Appendix 11 Written Comments Received on the Draft Environmental Impact Statement **JUDICIARY COMMITTEE**

## Testimony of Congressman Jerrold Nadler Before the City Planning Commission Regarding the Hudson Square Special District November 28, 2012 ULURP Application Numbers: C 120380 ZMM and N 120381 ZRM

## <u>TESTIMONY OF NEW YORK STATE SENATOR THOMAS K. DUANE</u> <u>BEFORE THE NEW YORK CITY PLANNING COMMISSION</u> <u>REGARDING THE PROPOSED HUDSON SQUARE REZONING</u> <u>ULURP APPLICATIONS:</u> 120380 ZMM, 120381 ZRM, 120381A ZRM

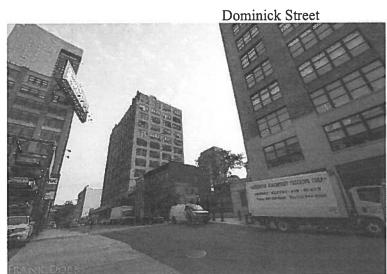
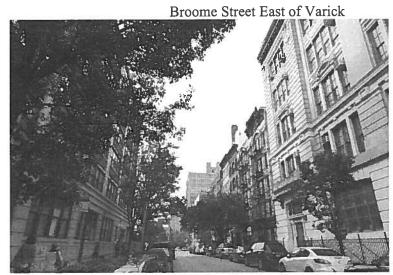
Attached are some photos that show how each block actually looks and how there is nothing there that is worth preserving.

We who live in this area know how ugly it is, and that's OK with us. But trying to "preserve" this ugliness is beyond bizarre.

Dominick is a two block dead end commercial street with very little foot or car traffic. The low rise houses are a small presence, and, with three out of four already landmarked, there is no possibility of a tall building ever. Downzoning serves no purpose.

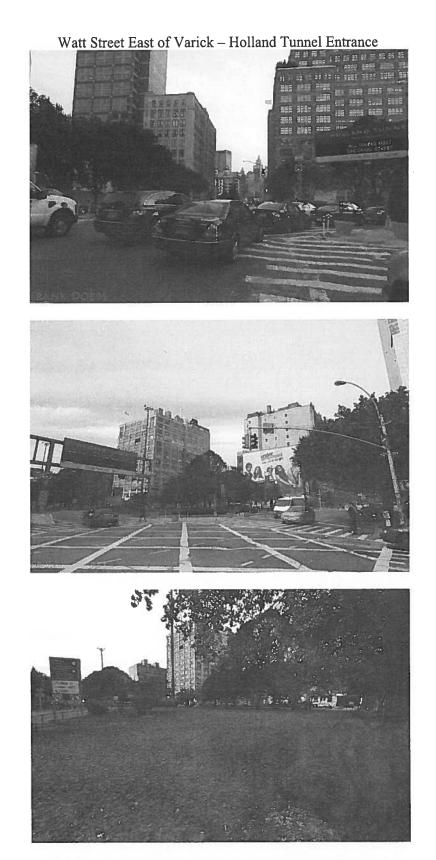
Lot to the south is downzoned. Lot to the North owned by Trinity is not. One of the worst traffic corners in the city. Broome Street, West of Varick

Rush hour traffic lasts 3 hours.

Includes an ugly 6 story garage.

Decrepit church and Tunnel.

View from Varick St.

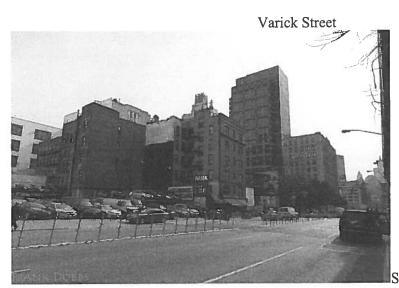
One half only of the the Tunnel entrance is in the subdistrict. Downzoning this parcel will have no impact. It seems to be in the subdistrict to make it look less arbitrary. In fact, it just shows how arbitrary the subdistrict boundaries are.
